From: Tom Fildes <tom.fildes@heneb.co.uk>
Sent: 25 July 2023 11:42
To: Ian Meyrick
Subject: RE: Welsh Water storage tank and pipework Bangor - Heritage review request

Welsh Water are proposing to upgrade/retro fit the sewage pumping station (SPS) at NGR:SH 58643 72908 in Bangor, and provide new storage tank (4300m³) and pipework in the adjacent playing field NGR: SH 58623 72849. In addition there will be mandatory interventions to improve and replace the 225mm pipe adjacent to Glandwr Road (NGR:SH 58526 73021) which is affected by tidal ingress.

Figure 1: Updated proposed works

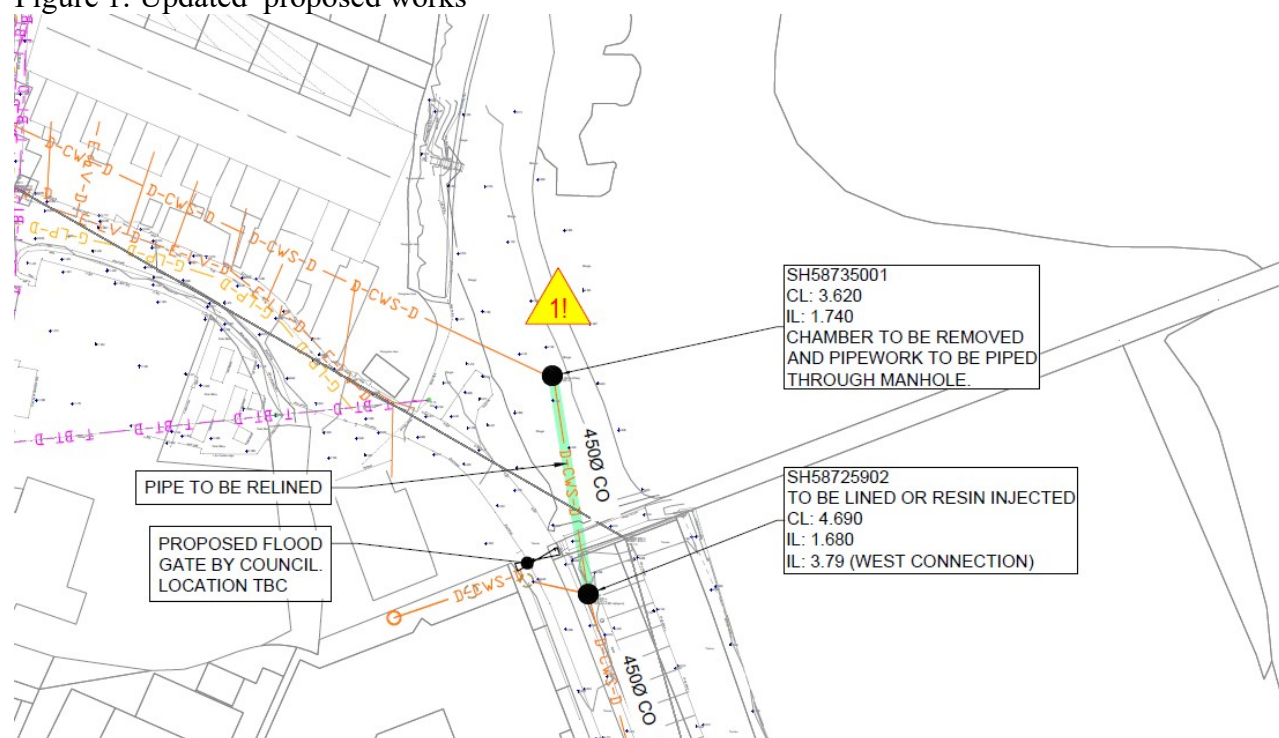
The proposed works near Glandwr Road (NGR:SH 58526 73021) has been changed since we last spoke. We will no longer be installing a new 225mm pipe trench: 32m (length) x 1.1m (width) x 3m (depth). See drawings ending CI5000 and CI5003. Instead we are proposing to modify the existing manhole and pipe that's already in place.

The updated proposed works are to fill in the existing manhole chamber (NGR SH 58530 73020), allowing for a pass through pipe to connect the incoming and outgoing pipe, and reline 20m of downstream pipe (see Figure 1).

The 20m of existing pipe will relined using UV Cured-in-Place-Pipe Lining (CIPP) methods. Access will be gained from the manhole located in the highway 20m south of the foreshore manhole (see Figure 2). No intrusive works or vehicle access to the foreshore will be required for this stage of the works.

All fine re. the Glandwr Rd arrangement, especially as you say, there being reduced excavation and much of the ground there having been disturbed. Yes there still needs to be archaeological monitoring for the works to the south.
